SUSITNA HYDROELECTRIC PROJECT

**ACRES INTERNAL REVIEW BOARD
MEETING # 4**

**REPORT
SEPTEMBER 8, 1981**

MINUTES OF MEETING
held at the offices of
Acres Consulting Services,
Niagara Falls, Canada on
September 8, 1981

PLATE 8.1
ALASKA POWER AUTHORITY
SUBTRA HYDROELECTRIC PROJECT
WATANA
VALVE TYPE SPILLWAY ALTERNATIVE
GENERAL ARRANGEMENT

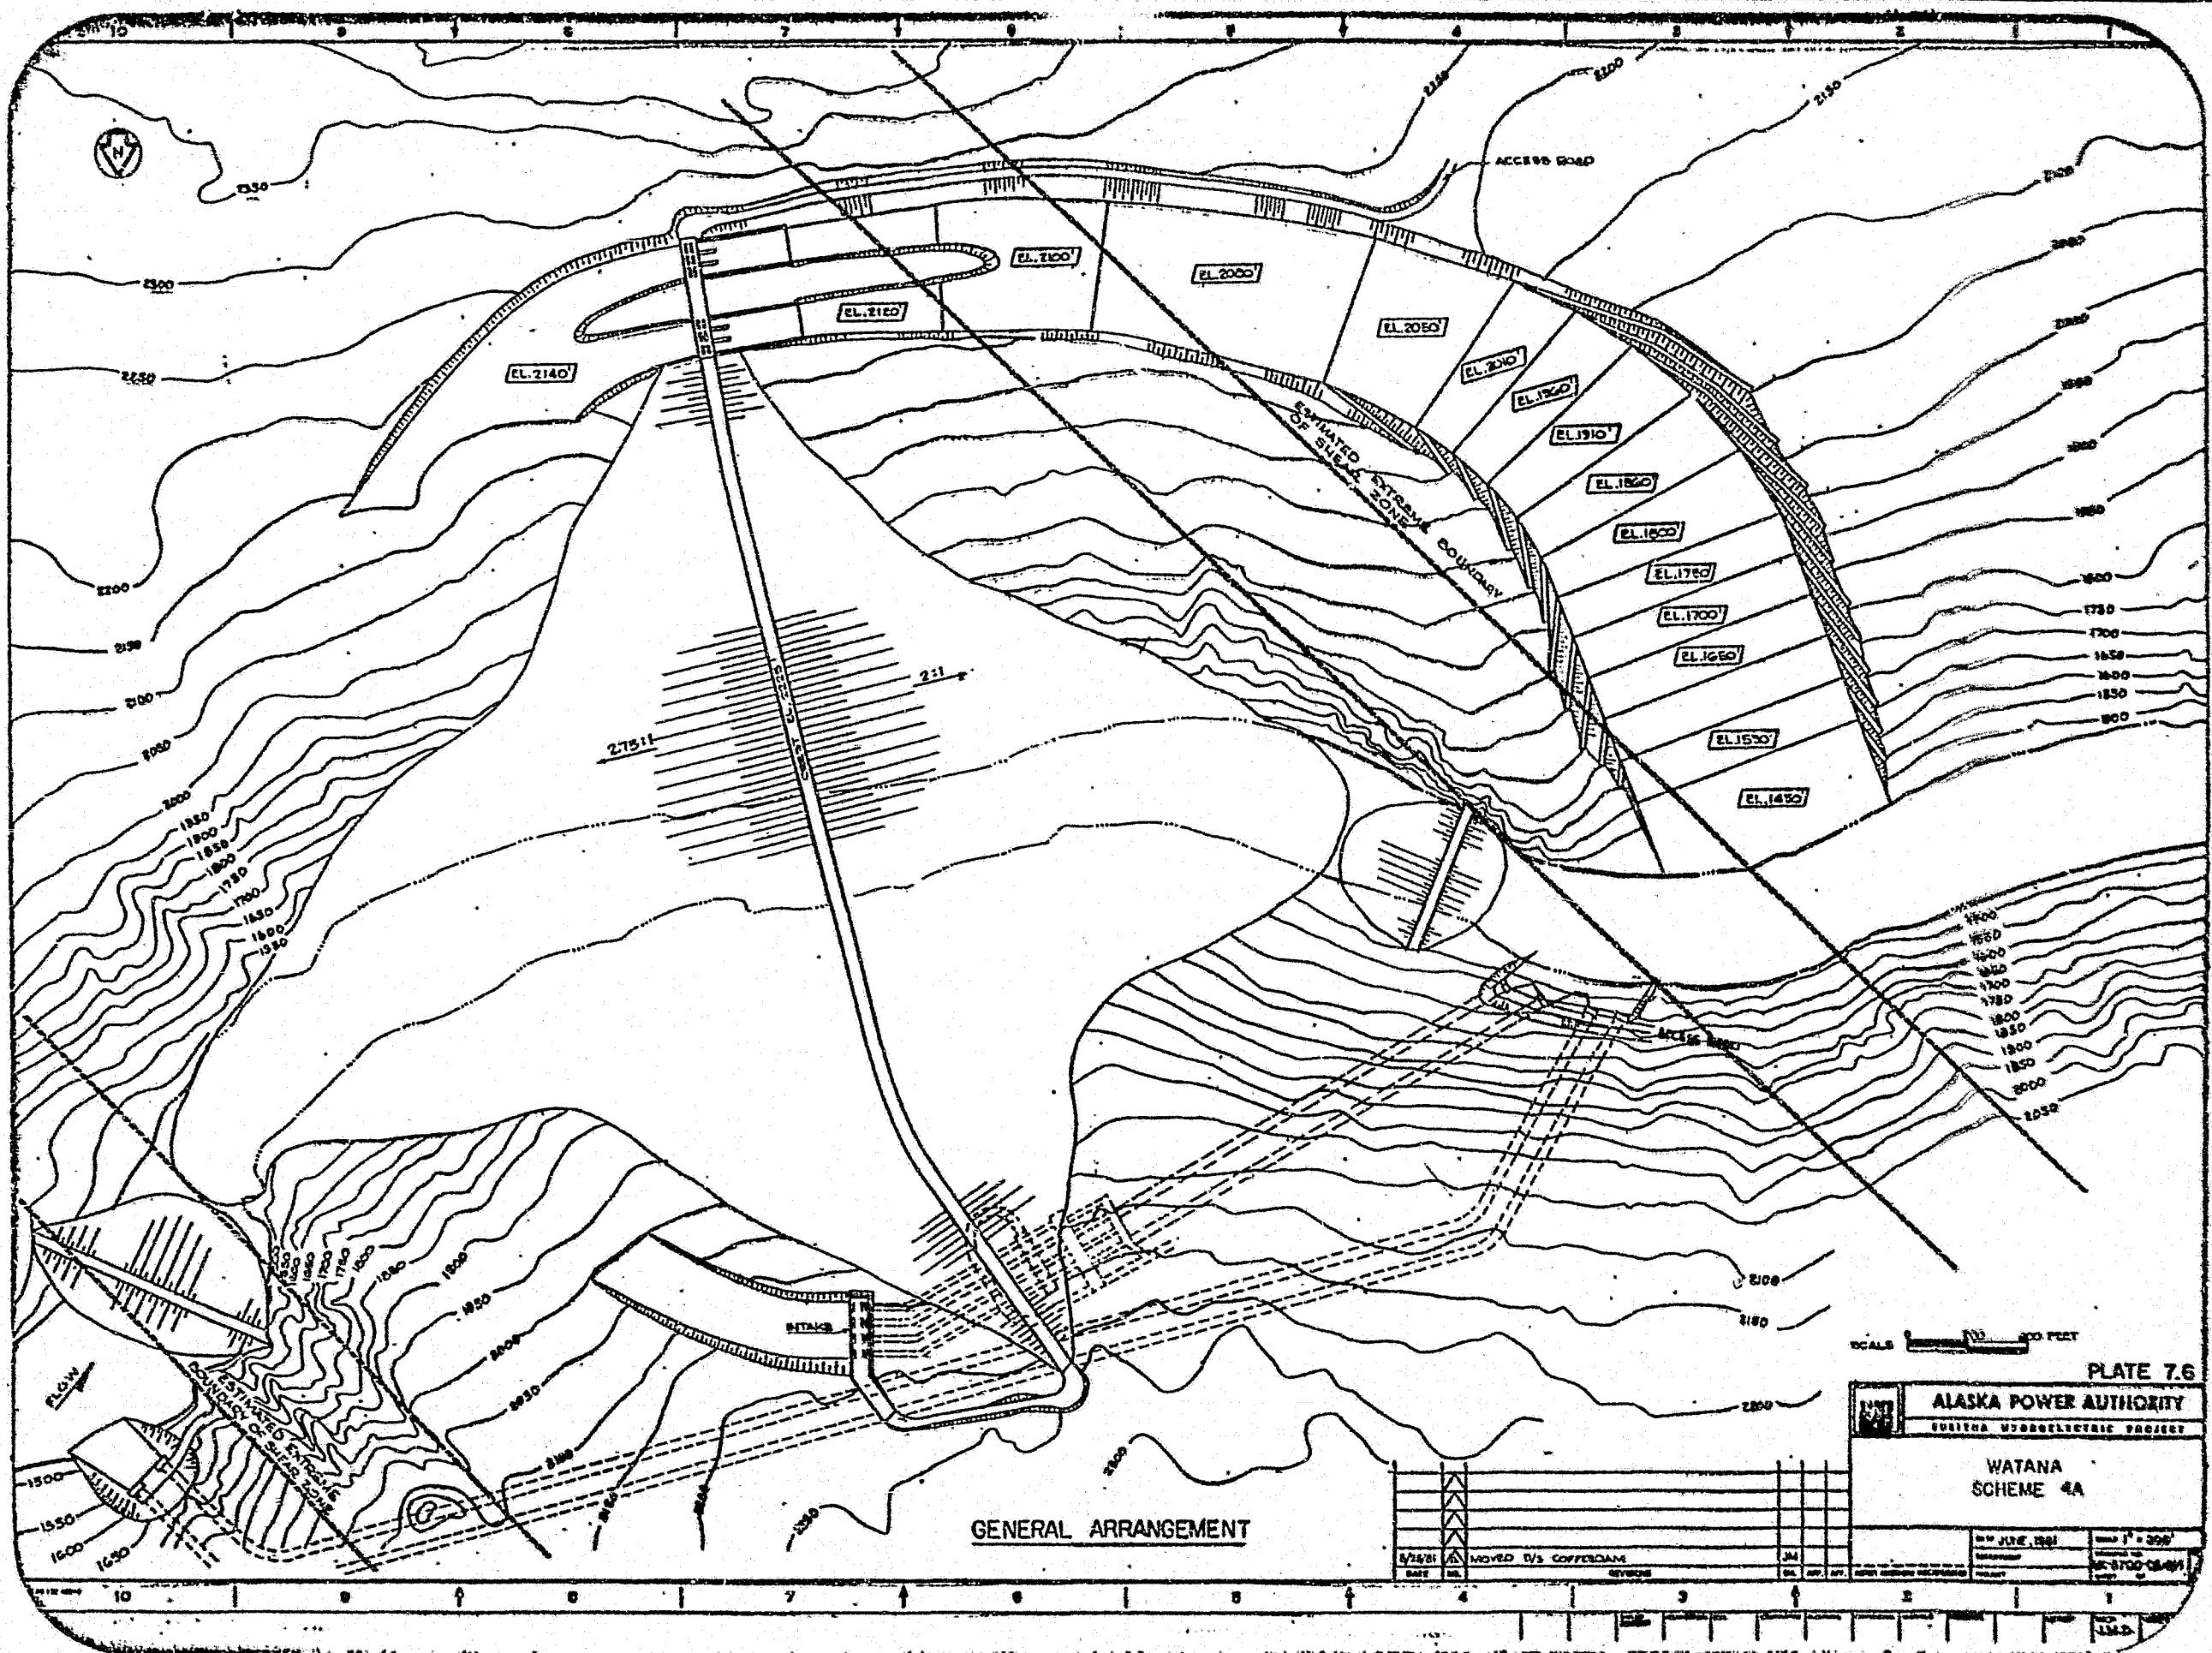
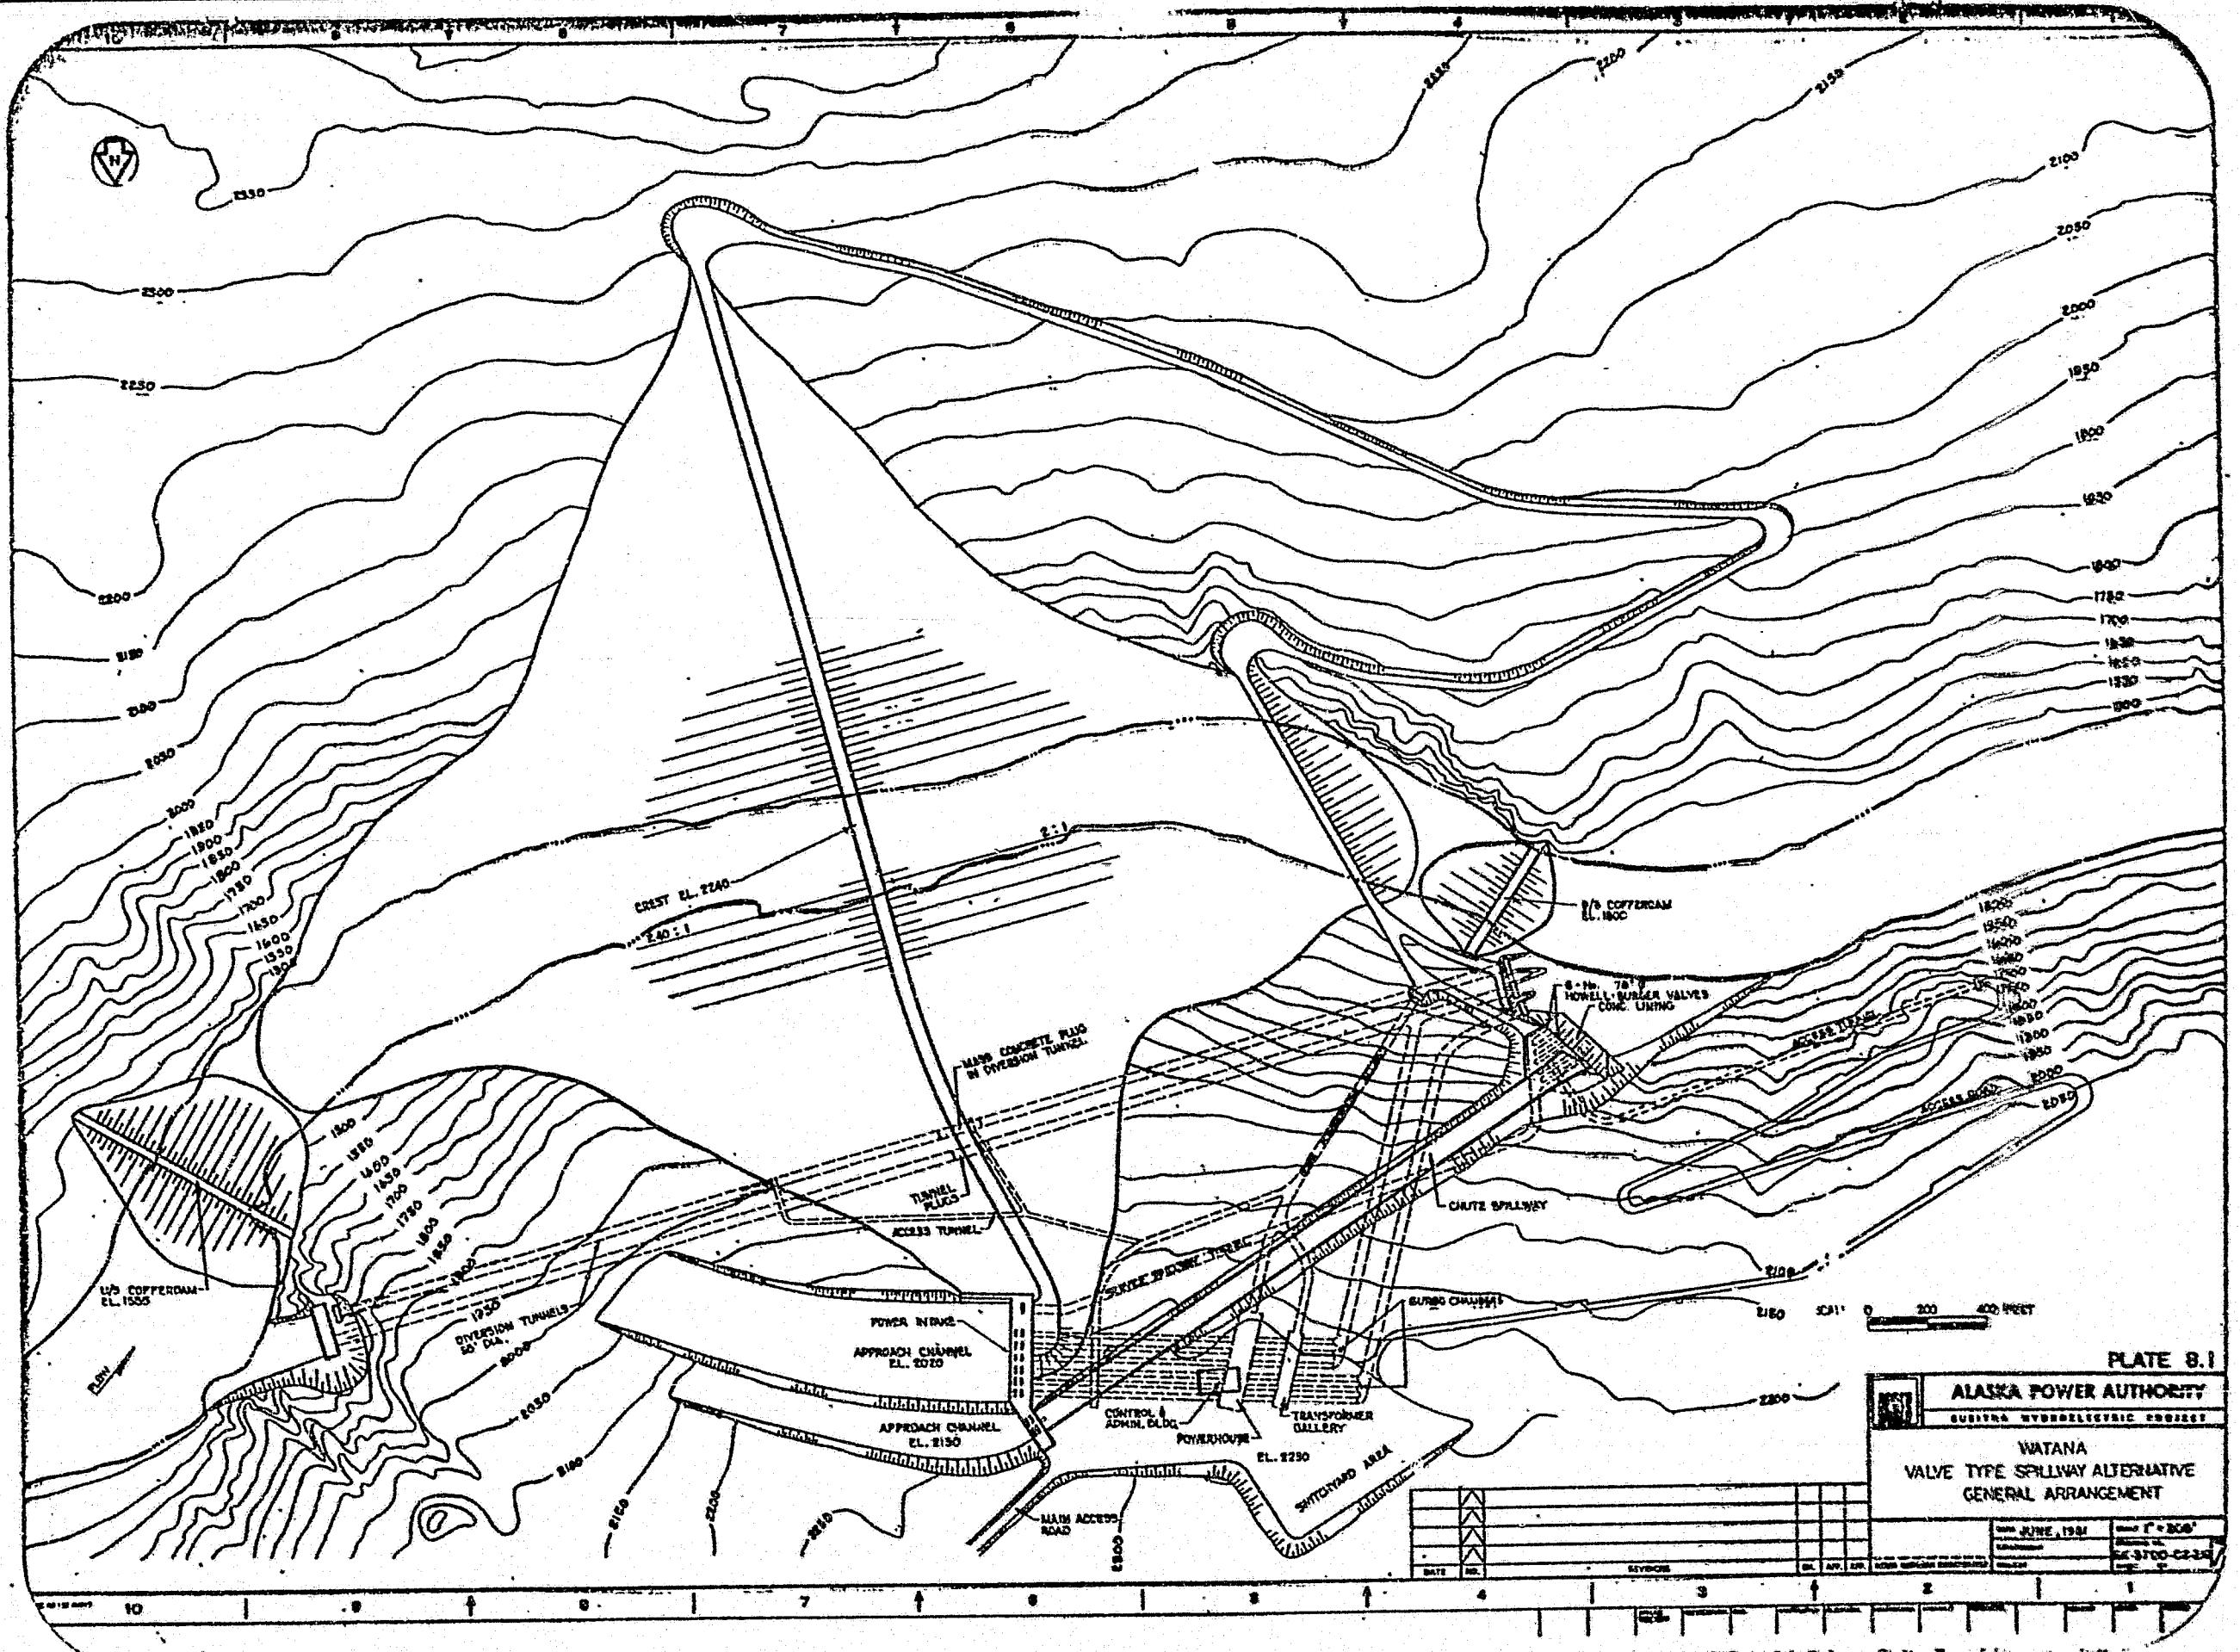
- Downstream tunnel portals are too close together for construction.
- Precedent for use of HB valves as primary release devices? Need for a report on their use was reiterated.
- Significance of upstream dam slope? Change from 2.75 to 2.40 reduces cost by \$10 million, with adjustment of dam center line.

The use of cascade spillways for service and auxiliary use should be considered in more detail at Watana.

← BURIED CHANNEL THALWEG

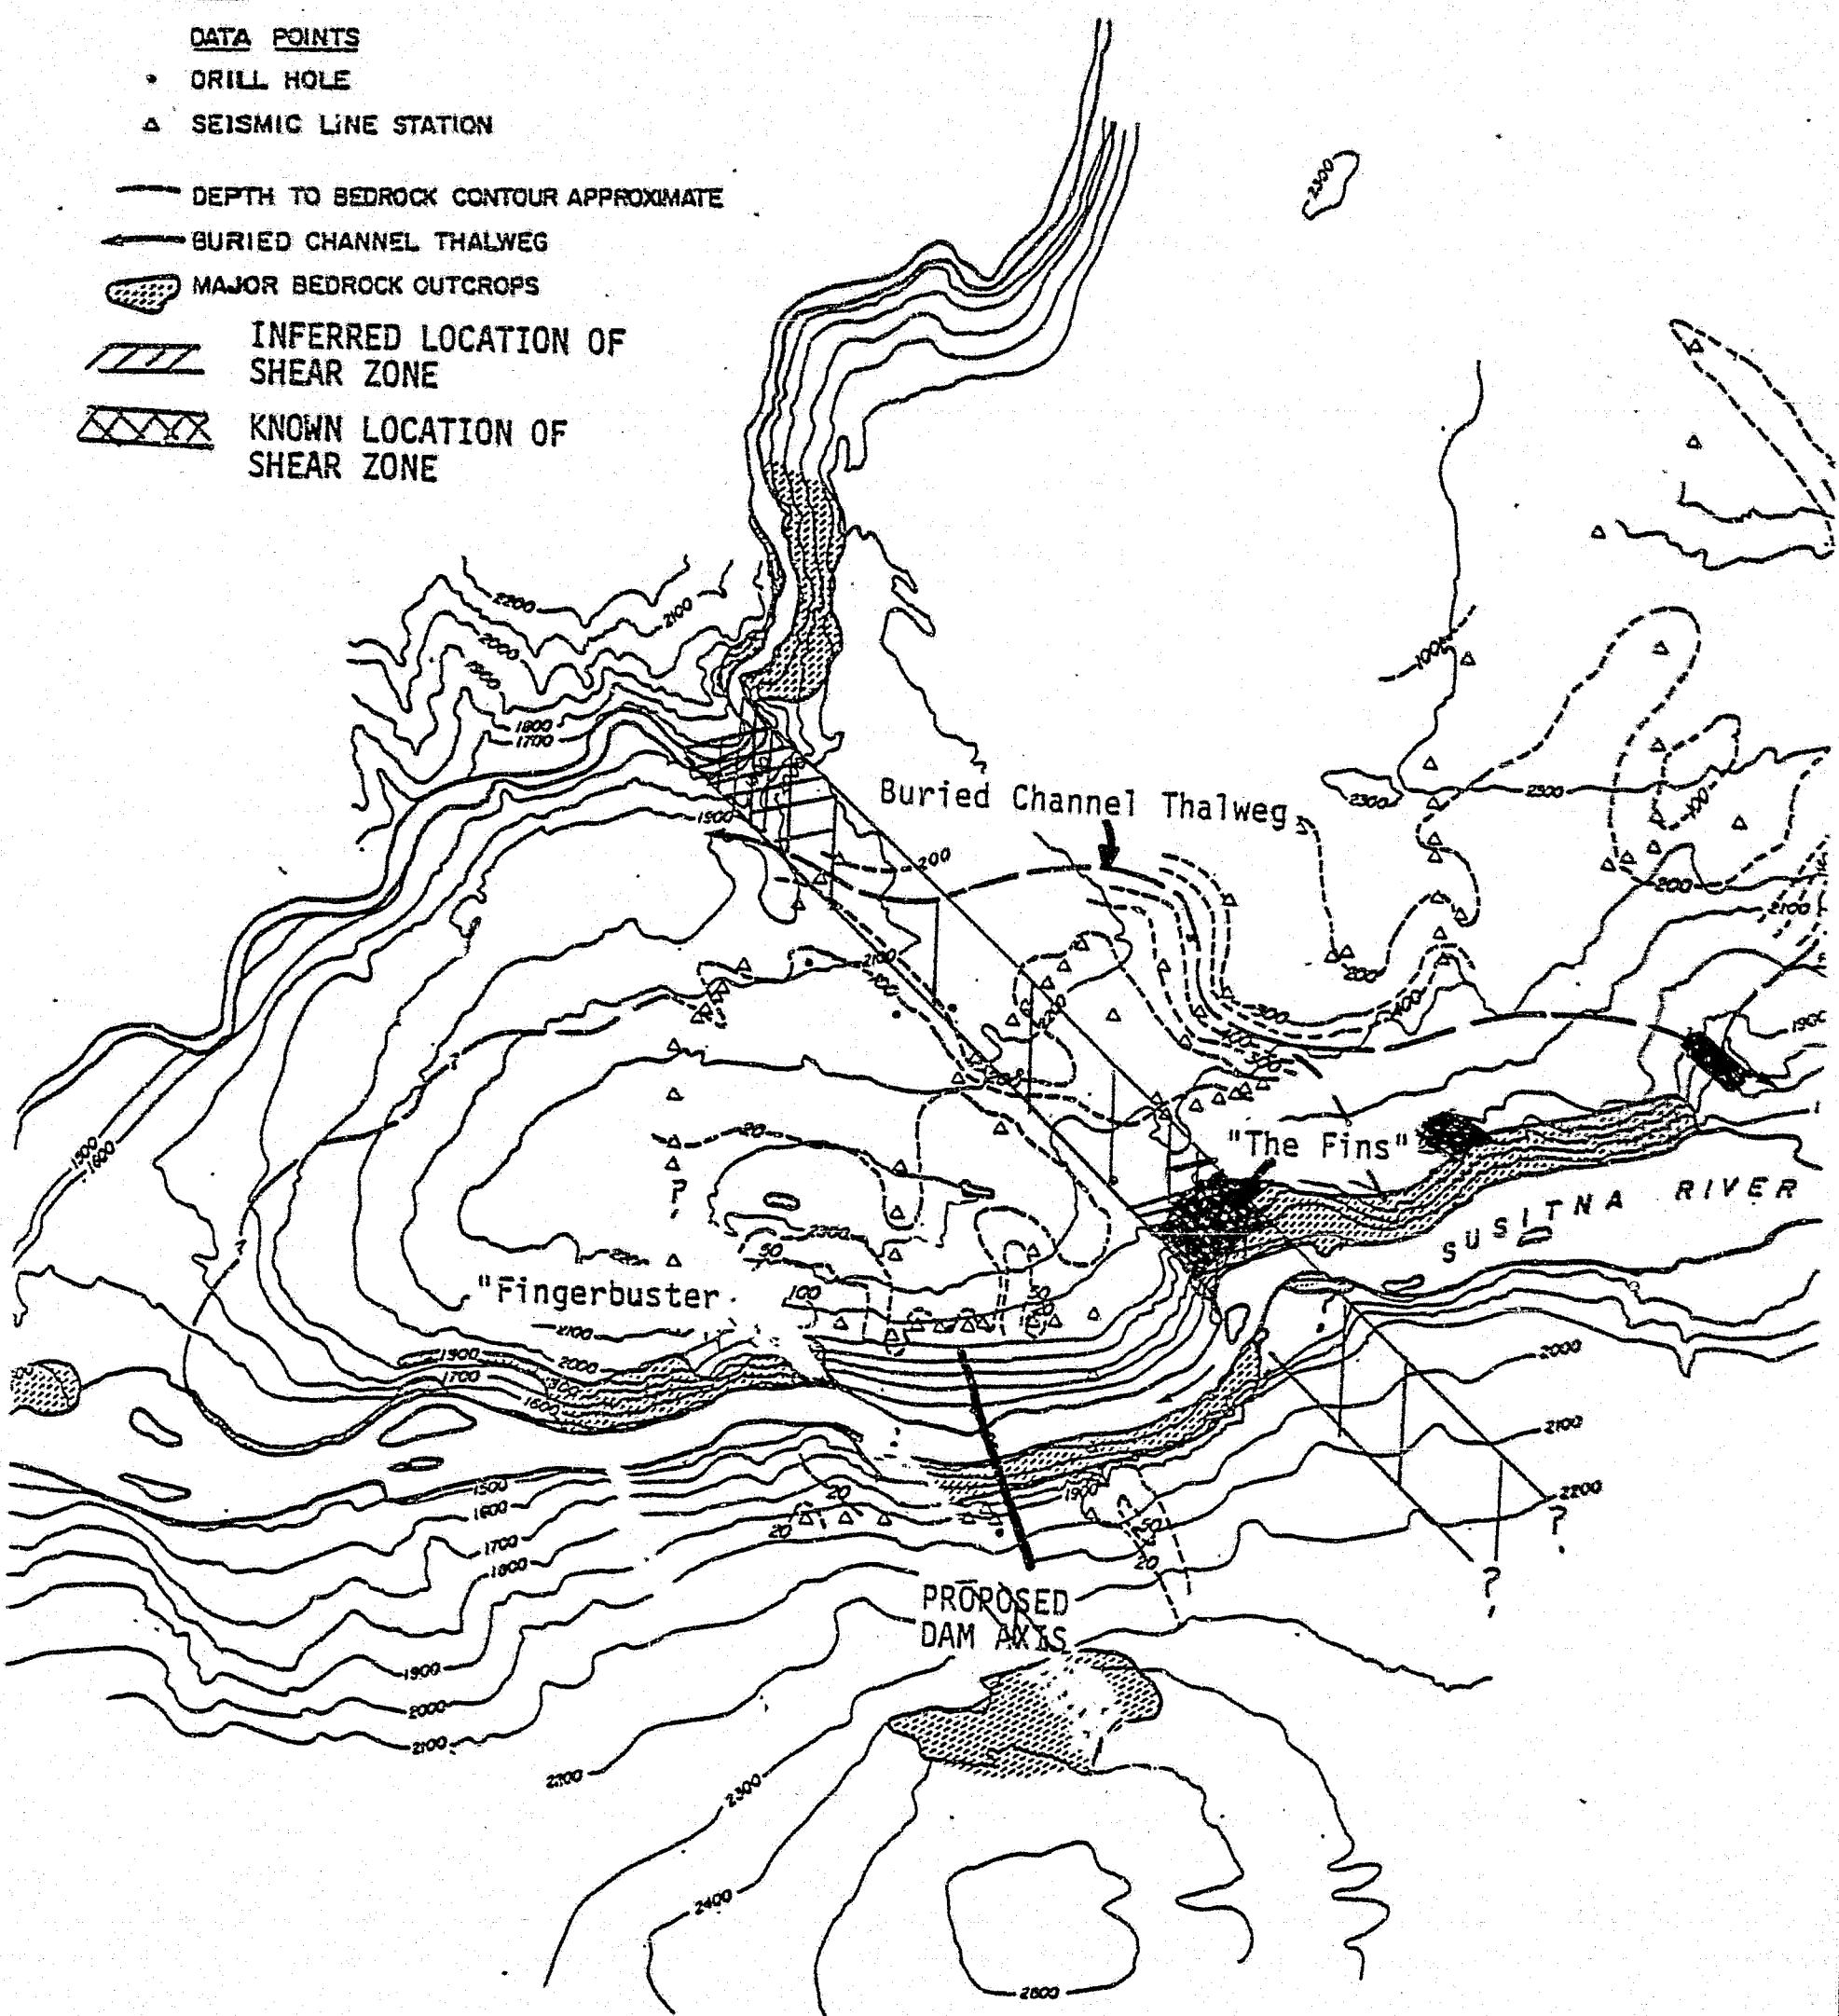
Board members believe that every effort should be made to expedite final logs of drill holes and drawings of geological plans and sections using old as well as new data. Early accomplishment of this will significantly aid the consideration of the fractured zone under the river at Devil Canyon.
